UNITED STATES PATENT AND TRADEMARK OFFICE

10/732,804

Office Action Summary

FIG. 2
CONVENTIONAL ART

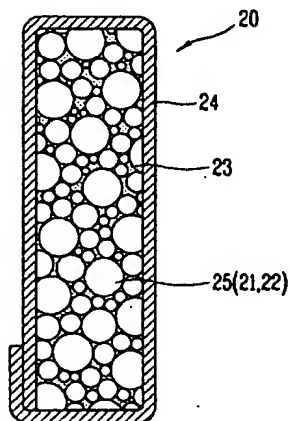
The AAPA makes known an electrode structure including a foam body 23 made of Ni in which mixture of electrode catalyst particles 21 made of metal halide (MH), and polytetrafluoroethylene 22 is infiltrated, and a mesh 24 made of Ni enclosing the foam body 23 (*See applicant's specification on page 3, lines 10-25/ FIGURE 2*).

The AAPA discloses in detail, a granule type electrode catalyst 21 and PTFE 22 mixed to a mixture 25 which is infiltrated in the foam body 23 to fill the void parts of the foam body 23; wherein the foam body 23 filled with the mixture 25 is enclosed by the mesh 24 which maintains the shape of the foam body 23 (*See applicant's specification on page 3, lines 10-25/ FIGURE 2*). *In this case, it is contended that either or both the foam body 23 and the mesh 24 act(s) as the claimed catalyst holding body; yet further, infiltration of the electrode catalyst granule-PTFE mixture in the foam body 23 encompasses certain degree of entanglement or wrapping or twisting. Note that the term "entangle" only means to wrap or twist together (Merriam-Webster's Collegiate Dictionary 10th Edition) but does not suggest any specific material and/or structure.*

Figure 2 below illustrates the conventional electrode structure disclosed by the applicant (See FIGURE 2).

The AAPA discloses a granule type electrode catalyst 21 (*See applicant's specification on page 3, lines 10-25/ FIGURE 2*).

The AAPA uses electrode catalyst particles 21 made of metal halide (MH) (*See applicant's specification on page 3, lines 10-25/ FIGURE 2*). It is noted that a metal halide is a hydrogen storage alloy.

The AAPA makes known an electrode structure including a foam body 23 made of Ni and a mesh 24 made of Ni enclosing the foam body 23 (*See applicant's specification on page 3, lines 10-25/ FIGURE 2*). In this case, it is contended that either or both the foam body 23 and the mesh 24 act(s) as the claimed catalyst holding body. Moreover, since the foam body 23 and the enclosing mesh are made of Ni, it is further contended that they represent a Ni-material contacting the electrode catalyst, thereby they serve as the claimed Ni layer.

The AAPA uses polytetrafluoroethylene 22 to make the electrode (*See applicant's specification on page 3, lines 10-25/ FIGURE 2*).
